This errata sheet provides updated information on Stratix™ engineering sample (ES) devices. Altera has identified four silicon issues affecting these devices. This document addresses the issues and includes methods to work around the issues.

Stratix Family Issues

Figure 2. Gated Lock in Internal Logic Circuit

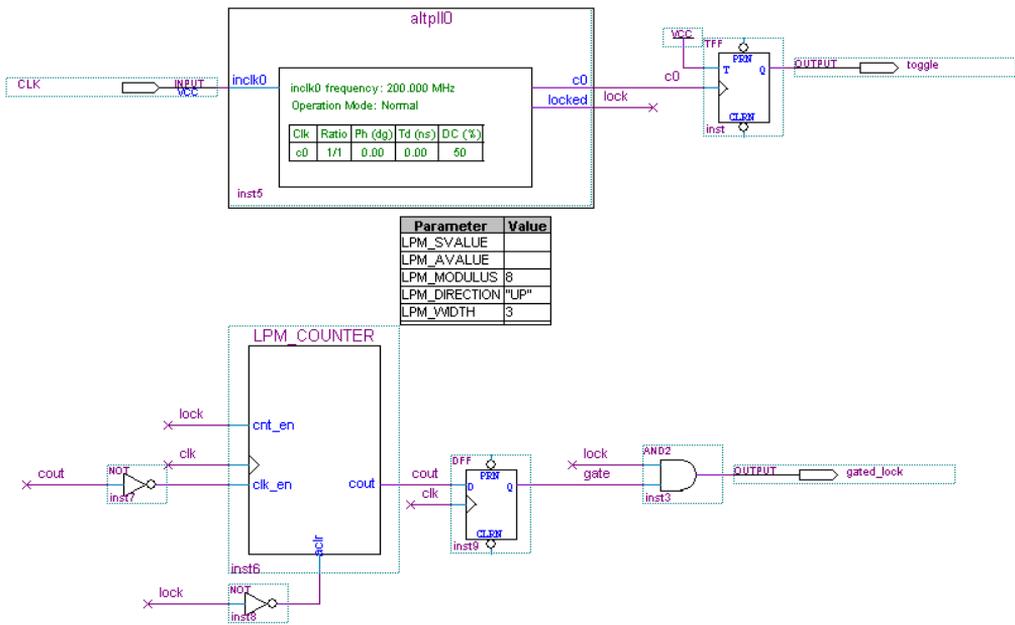
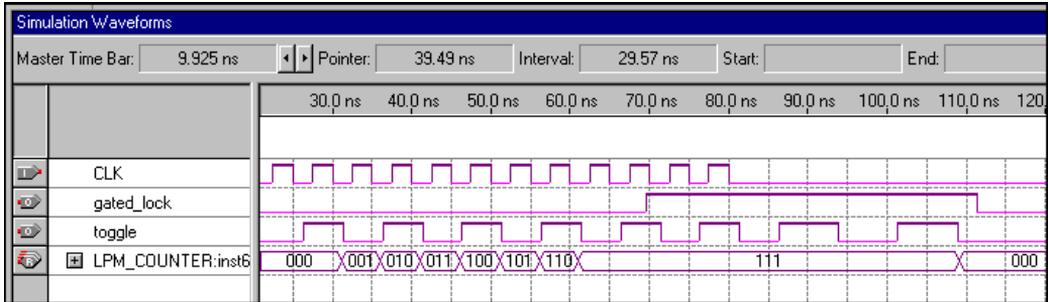
There is a run-through problem in the GLOCK counter that causes the counter to operate incorrectly. Support for the gated lock circuitry was disabled in the Quartus II software version 2.1. Therefore, the gated lock feature is unavailable in Stratix devices.

The work around for this problem is to gate the lock signal in internal logic. Altera recommends using a two-input AND gate to gate the lock signal with a counter. The counter determines how many clock cycles before the lock signal is released. See Figure 2.

Figure 4. Clock Switchover Circuit

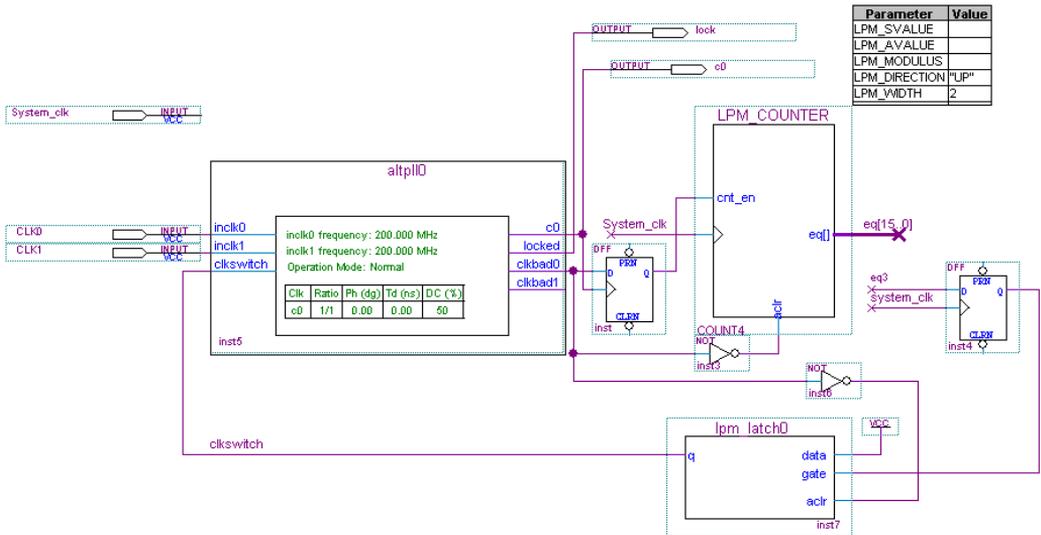
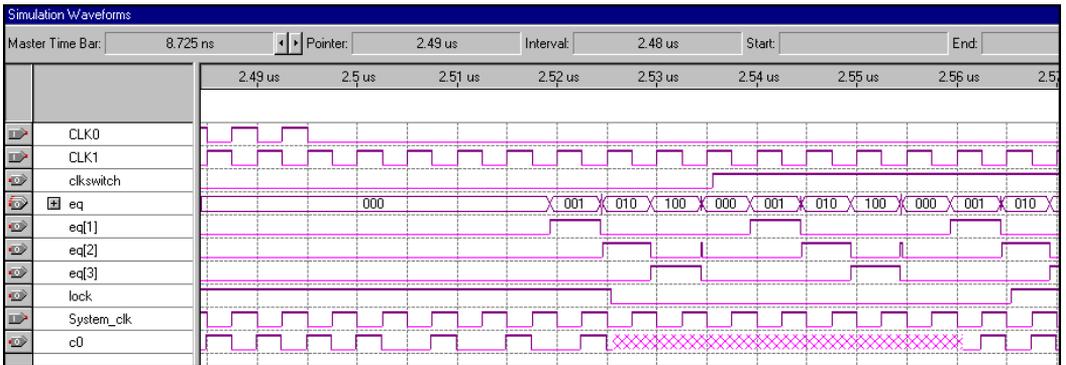
The CLKBAD0 and CLKBAD1 signals have a design flaw that causes a glitch in the signals. The glitches last for a half clock cycle. CLKBAD0 and CLKBAD1 are available for designers to use to control switchover internally.

To work around this issue, the designer should implement the circuit shown in Figure 4 to monitor the CLKBAD signal of the primary clock and initiate a switchover when the primary clock fails. The CLKBAD signal must be high for four clock cycles (the two-bit counter reaches four) before the circuit switches to the secondary clock. The counter will be cleared if there is a glitch in the CLKBAD signal it goes low in error before the counter reaches four. The CLKBAD signal is registered before driving the counter's cnt_en signal to prevent metastability. The clkswitch signal is latched so that it will only trigger a switch from the primary clock to the secondary clock.

In the circuit shown in Figure 4, CLK0 is the primary clock and CLK1 is the secondary clock. The circuit monitors the CLKBAD0 signal to determine when the clock driving CLK0 is lost.
